**Top dishwasher basket scrapes on the outer door
New outer door seal spare-part no. 426976**

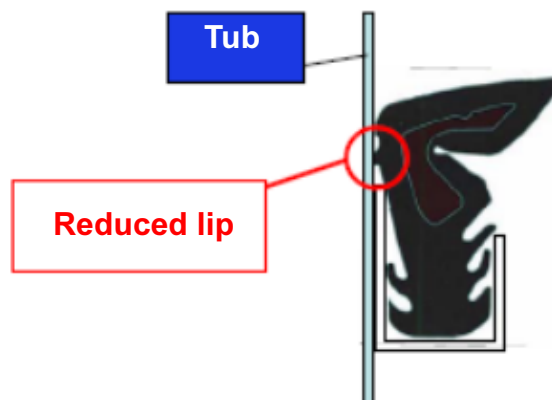
We wish to inform you that a new outer door seal has been implemented for all of the 60 cm dishwashers produced as of March 2007 (series no. 710xxxxx). The modification involves reduction of the lip which makes contact with the wall of the tub (see illustration).

The new outer door seal must be used for technical modifications to appliances whose series no. is before 710xxxxx due to interferences between the top basket rail and the outer door seal.
